ADDENDUM NO. 1

November 4, 2025

Schoellkopf Memorial Hall Men's Locker Room Renovation

**SCHOELLKOPF
MEMORIAL HALL
MEN'S FOOTBAL
LOCKER ROOM
RENOVATION**

M-101R
17245792

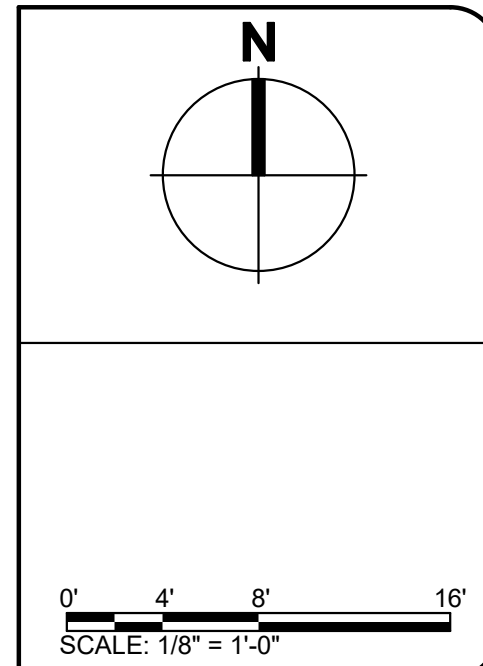
5	M-101		Do we need to keep the women's locker room exhaust functioning while we're working?	Women's lacrosse will be ongoing during the construction period. The season will start in January. The sequencing of this work will have to be carefully coordinated with the successful bidder. However, one suggestion that could work would be to time this work for June or July.
6			Is BSI (Owner's Audio installers) a Union contractor?	BSI will utilize a crew that is part of Local 289 for installation and terminations.
7	A-102, M-501	General Renovation Notes and Finish Legend	PT5 paint new ductwork was mentioned at pre-bid, but does not appear to be indicated on the floor plan.	See Addendum No. 1, Item 2 and see Drawing M-501, DUCT SCHEDULE AND SPECIFICATIONS Spec 17: ["ALL DUCTWORK AND INSULATION THAT'S LOCATIONS ARE EXPOSED AND ABOVE BAFFLE CEILING SHALL BE PAINTED, REFER TO ARCHITECTURAL."]
8			Should the existing perimeter walls that are currently painted red, be painted white?	The existing walls can remain as is.
